11302, 11306, 11308, 11312, 11316, 11320, 11322 and 11326 - 79 Street NW; 11303, 11305, 11307, 11311, 11315, 11317, 11321 and 11323 - 80 Street NW; and 7300 - 116 Avenue NW
Position of Administration: Support

Bylaw 21234 proposes a rezoning from the Urban Facilities Zone (UF) and the Medium Scale Residential Zone (RM h16.0) to the Public Utility Zone (PU) to allow for the development of stormwater management facilities (SWMFs). Charter Bylaw 21232 proposes an amendment to the North Central District Plan to facilitate the proposed rezoning. Bylaw 21233 proposes an amendment to the Exhibition Lands Planning Framework (ELPF) to facilitate the proposed rezoning.

Exhibition Lands Planning Framework (ELPF) Summary of Proposed Amendments

Exhibition Lands Planning Framework Proposed Figure Amendments

Proposed Figure 12 Overall Concept Illustration

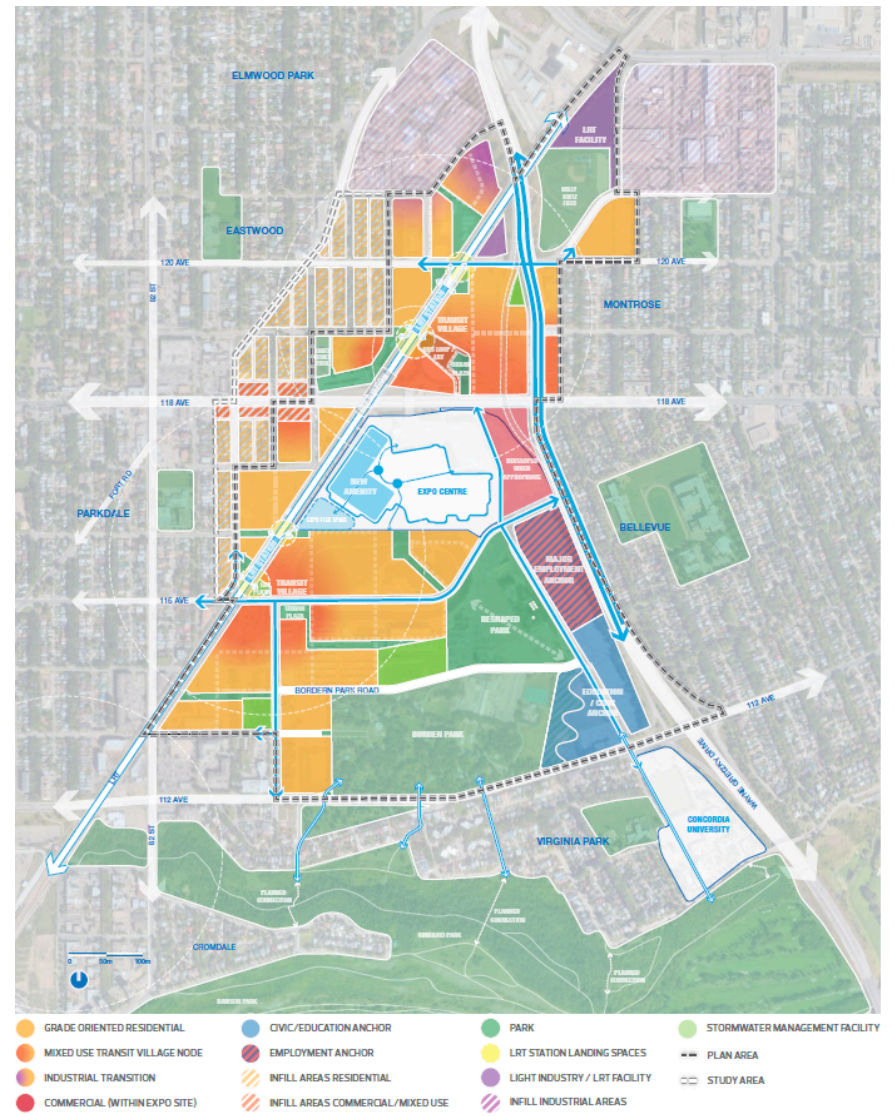
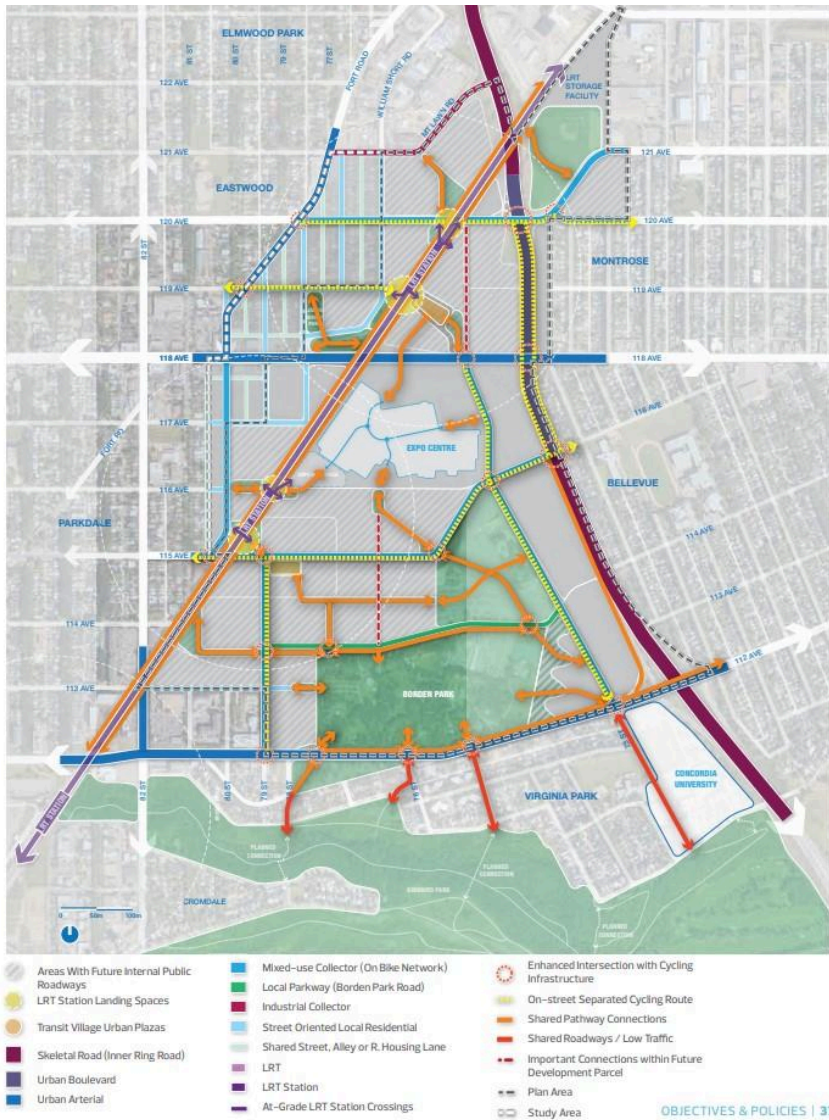
ELPF Figure	Summary of Proposed Amendments	Rationale
Cover page	- Resized image	Resized to show the image content more clearly.
P.g. IV	- Resized image	
Figure 11 Visualization of the Redevelopment Concept for the Exhibition Lands P.g. 31	- Resized image and repositioned number tags	
Figure 12 Overall Concept Illustration P.g. 33	<ul style="list-style-type: none"> - Renamed from 'Figure 12 Development Concept' <p>Legend:</p> <ul style="list-style-type: none"> - Added 'Stormwater Management Facility' - Added 'Infill Areas Commercial/Mixed Use' - Renamed 'Green Space' to 'Park' - Renamed 'Incremental Industrial Areas' to 'Infill Industrial Areas' - Renamed 'Incremental Infill Areas' to 'Infill Areas Residential' <p>Figure:</p> <ul style="list-style-type: none"> - Added existing and proposed SWMFs in alignment with the Neighbourhood Design Report (NDR) 	<p>All figures were updated to more accurately represent the land use areas. The statistics and figures are now aligned.</p> <p>Stormwater Management Facilities added to the legend and the figure to reflect the proposed servicing approach. Stormwater Management Facilities were not contemplated in the current ELPF.</p> <p>Parks were updated in alignment with the Parkland Impact Assessment (PIA), including the integration of Stormwater Management Facilities into the open space network.</p> <p>Renaming of some legend items to improve clarity.</p>

<ul style="list-style-type: none"> - Clearly showing Borden Park Road NW - Aligned parks with the Parkland Impact Assessment (PIA) - Mapping updates to more accurately represent the land use areas on the figure 	
<p>Figure 13 Land Use Concept Map</p> <p>P.g. 39</p>	<ul style="list-style-type: none"> - Renamed from 'Figure 16 Land Use Concept Map' - Added existing and proposed SWMFs in alignment with the Neighbourhood Design Report (NDR) - Aligned parks with the Parkland Impact Assessment (PIA) - Mapping updates to more accurately represent the land use areas on the figure 	
<p>4.1.1 Mixed Use Transit Village Node - South Vignette</p> <p>P.g. 40</p>	<ul style="list-style-type: none"> - Park space updated to align with the Parkland Impact Assessment (PIA) - Mapping updates to more accurately represent the land use areas on the figure 	<p>Figure numbers updated to reflect reordering.</p> <p>All figures were updated to more accurately represent the land use areas. The statistics and figures are now aligned.</p>

Proposed Figure 27 Mobility Concept Map

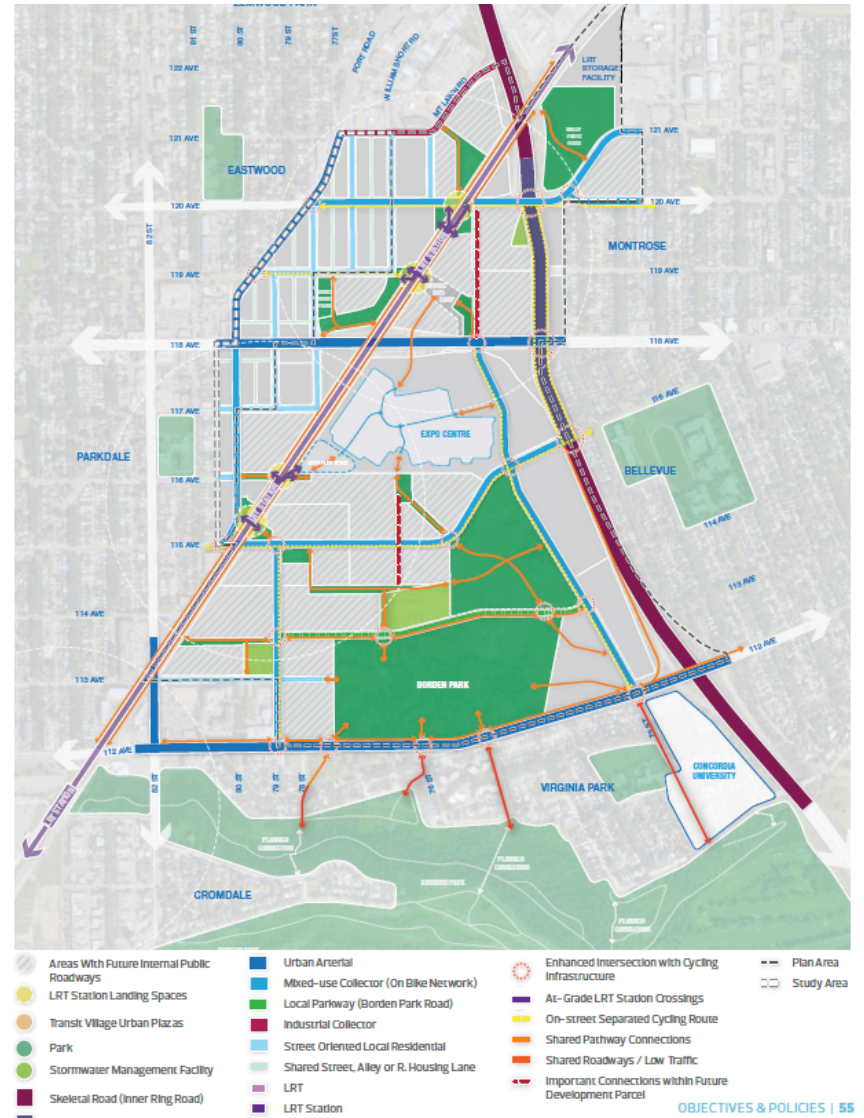
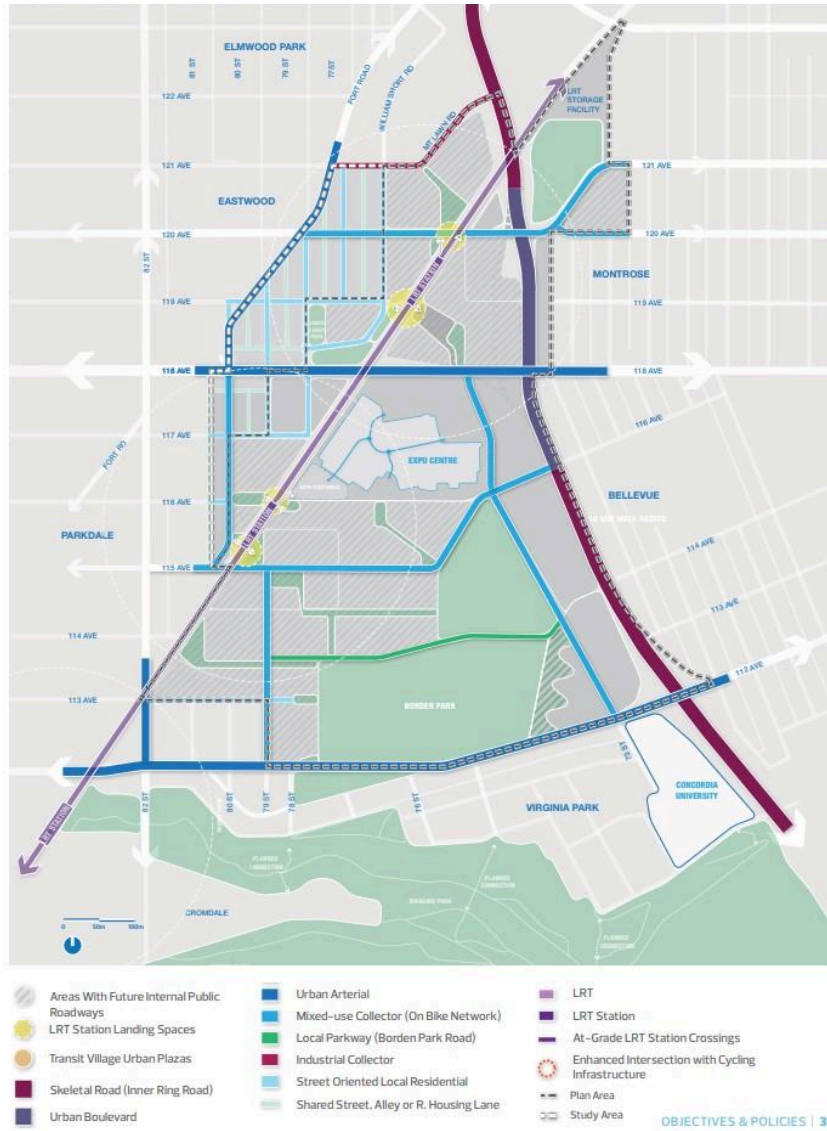
<ul style="list-style-type: none"> - Added 'Stormwater Management Facility' - Updated 'local parkway' icon <p>Figure</p> <ul style="list-style-type: none"> - Added existing and proposed SWMFs in alignment with the Neighbourhood Design Report (NDR) - Aligned parks with the Parkland Impact Assessment (PIA) - Updated local parkway on map to match new legend icon. - Added 'Enhanced intersection with Cycling Infrastructure' icon at intersection of 73 Street and Borden Park Road NW. - Added a shared pathway along the north side of 112 Avenue NW from 77 Street to 82 Street NW. - 113 Ave NW expanded eastward as a street oriented local residential road. - Mapping updates to more accurately represent the land use areas on the figure 	<p>Stormwater Management Facilities added to the legend and the figure to reflect the proposed servicing approach in alignment with the accepted Neighbourhood Design Report (NDR). Stormwater Management Facilities were not contemplated in the current ELPF.</p> <p>Parks were updated in alignment with the Parkland Impact Assessment (PIA), including the integration of Stormwater Management Facilities into the open space network.</p> <p>Updates to the shared pathway connections network to integrate the Stormwater Management Facilities with the active transportation network (e.g. addition of a shared pathway connection on the west side of the proposed western SWMF)</p> <p>Renaming of some legend items to improve clarity.</p>

Proposed Figure 28 Street Hierarchy Map

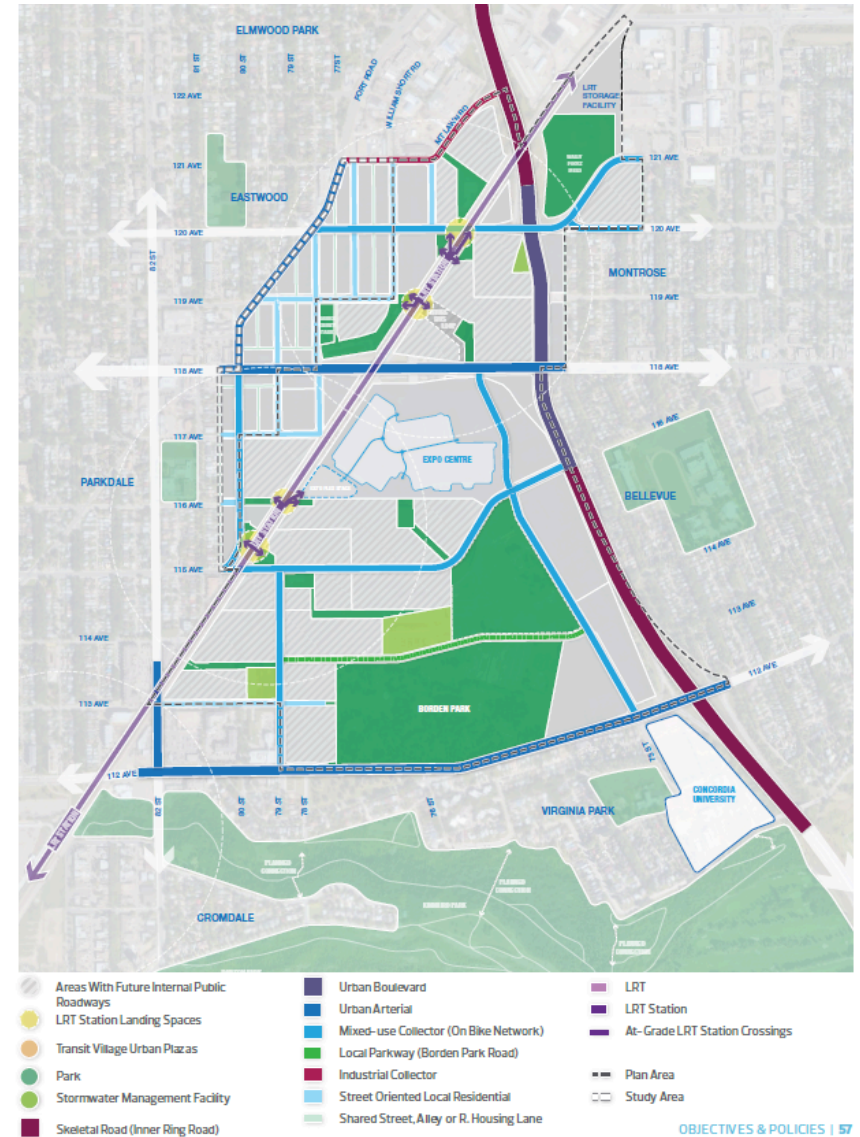
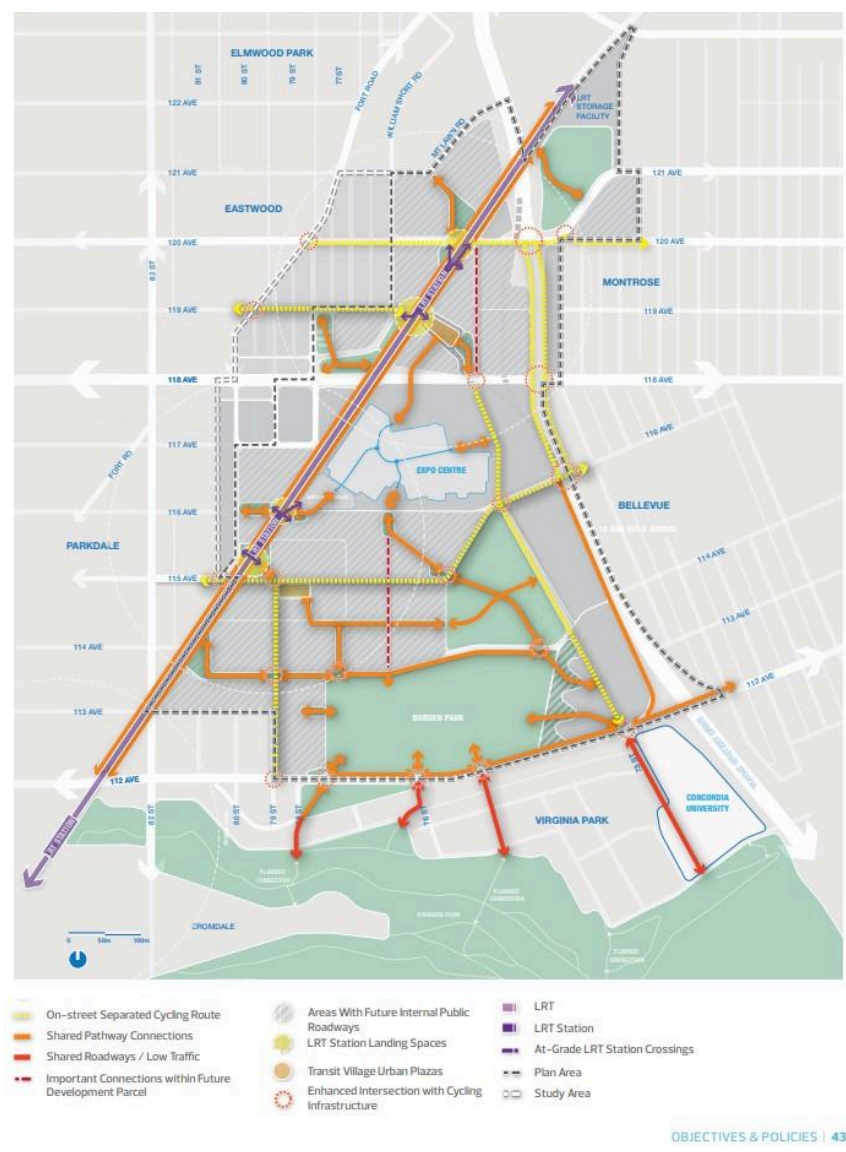
<p>Figure 28 Street Hierarchy Map</p> <p>P.g .57</p>	<ul style="list-style-type: none"> - Renamed from "Figure 14: Street Hierarchy Map" <p>Legend:</p> <ul style="list-style-type: none"> - Added 'Park' - Added 'Stormwater Management Facility' <p>Figure:</p> <ul style="list-style-type: none"> - Added existing and proposed SWMFs in alignment with the Neighbourhood Design Report (NDR) - Aligned parks with the Parkland Impact Assessment (PIA) - 113 Ave NW expanded eastward as a street oriented local residential road. - Updated local parkway on map and legend.

Proposed Figure 29 Active Transportation Map

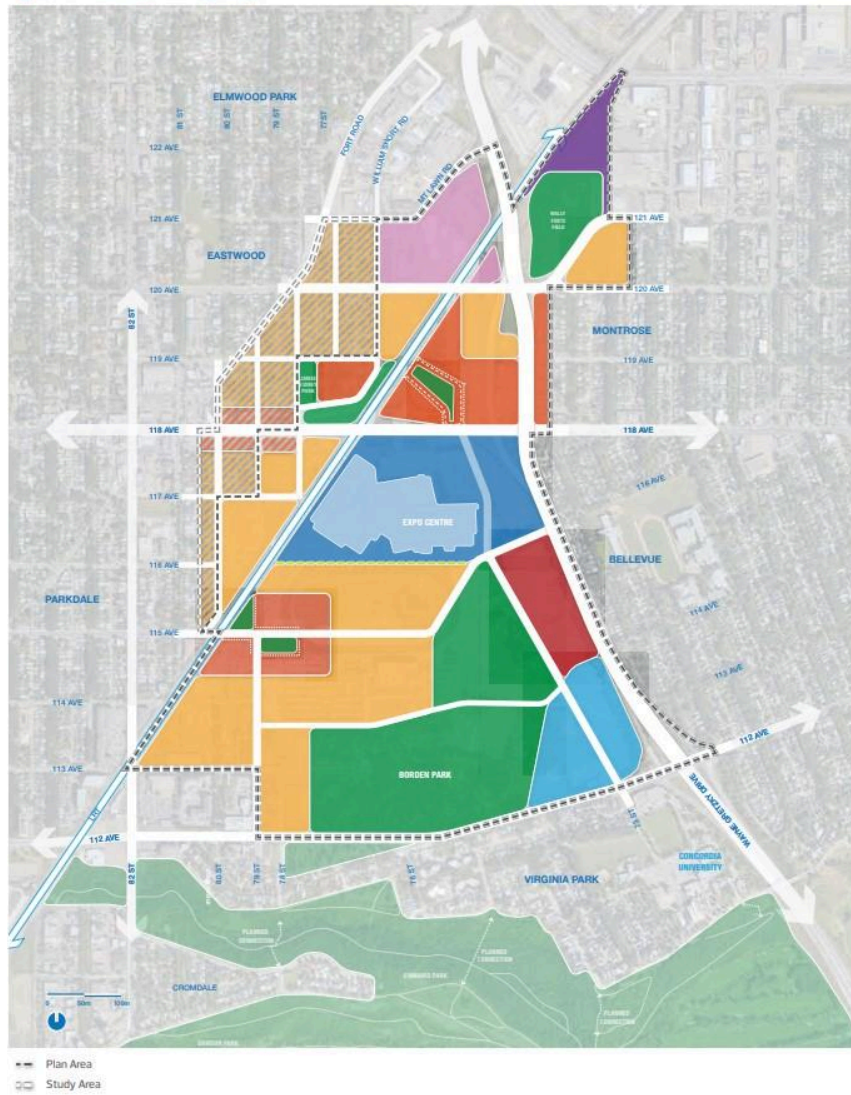
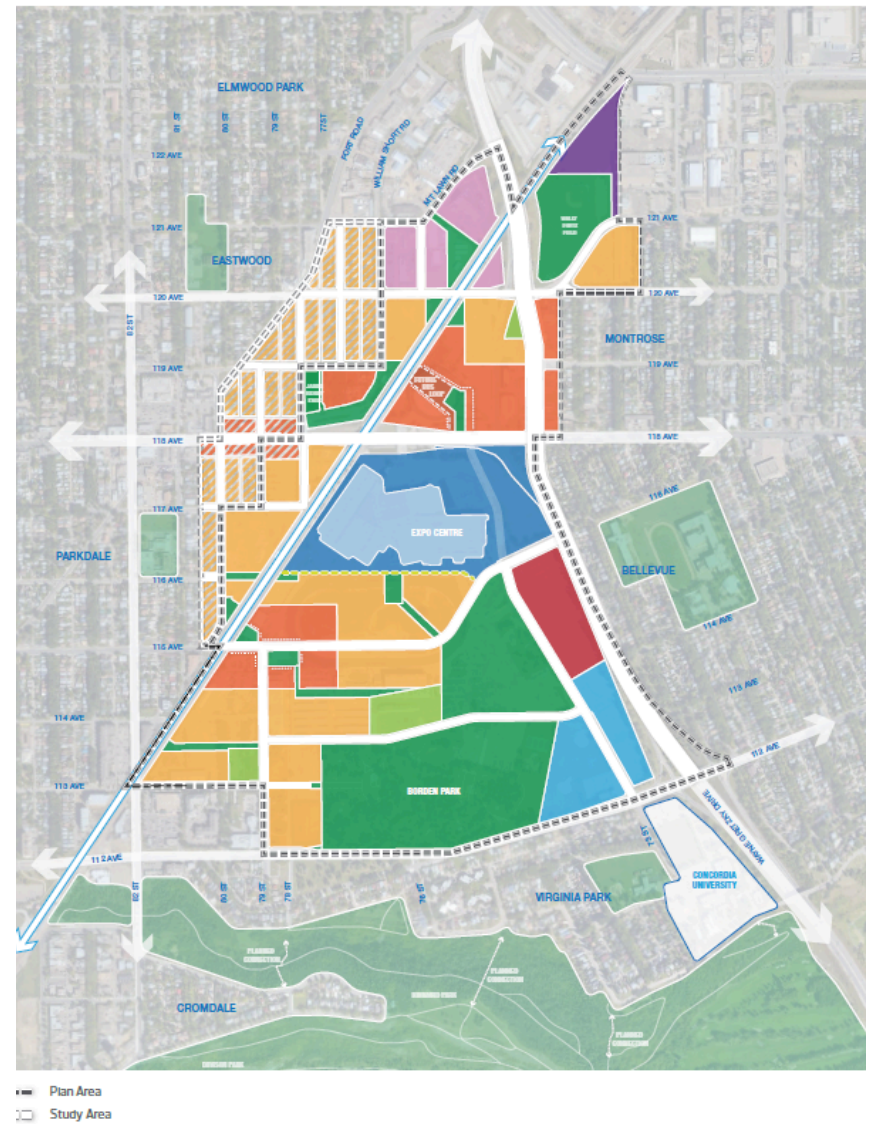
<ul style="list-style-type: none"> - Mapping updates to more accurately represent the land use areas on the figure 	
<p>Figure 29 Active Transportation Map</p> <p>P.g. 61</p>	<ul style="list-style-type: none"> - Renamed from “Figure 15 Active Transportation Map”. <p>Legend:</p> <ul style="list-style-type: none"> - Added ‘Park’ - Added ‘Stormwater Management Facility’ <p>Figure:</p> <ul style="list-style-type: none"> - Added existing and proposed SWMFs in alignment with the Neighbourhood Design Report (NDR) - Aligned parks with the Parkland Impact Assessment (PIA) - Added ‘Enhanced intersection with Cycling Infrastructure’ icon at intersection of 73 Street and Borden Park Road NW - Added a shared pathway along the north side of 112 Avenue NW from 77 Street to 82 Street NW - Mapping updates to more accurately represent the land use areas on the figure 	
<p>Figure 30 Water Servicing</p> <p>P.g. 64</p>	<ul style="list-style-type: none"> - Added existing and proposed SWMFs in alignment with the Neighbourhood Design Report (NDR) - Changes to the water servicing map as per the NDR. 	<p>Updates to the servicing section of the plan are proposed to align with the accepted Neighbourhood Design Report (NDR). Changes include the addition of Stormwater Management Facilities to the ELPF, and changes to the sanitary sewer and storm sewer serving.</p>
